Addendum 02

CUSD Plant Operations
District Office Expansion Phase 02
Clovis, CA

Date : January 10, 2024
TETER Project No.: 12560

DISTRICT OFFICE EXPANSION Ph2
Metal Building Addendum 02
Clovis Unified School District

Figure 3-3B: Filled Cavity Insulation for Metal Building Roofs

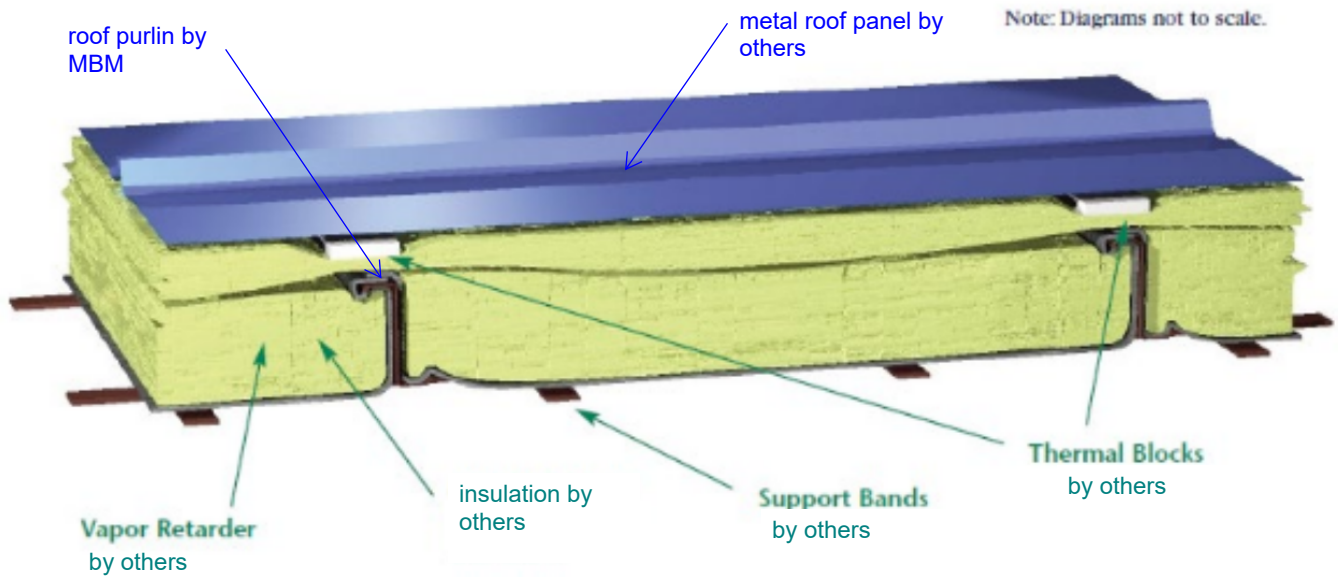
2-20: KEYNOTE 7.27 ON THE ROOF PLANS FOR ALL FOUR BUILDINGS CALLS OUT RIBBED METAL ROOF PANEL O/FURRING STRIPS O/INSULATION O/VAPOR BARRIER O/METAL DECK. DETAIL 5/A800 SHOWS ONLY METAL ROOFING OVER ROOF PURLINS. PLEASE CLARIFY WHAT ROOFING IS REQUIRED FOR EACH BUILDING AND WHAT MATERIAL TO INCLUDE IN OUR PRICING.

Response: The roof assembly, which includes insulation and all items occurring over the MBM purlins, are by others and should not be included in MBM pricing. Refer to AD1-A01 for a sample roofing section which is the basis of design for this project.
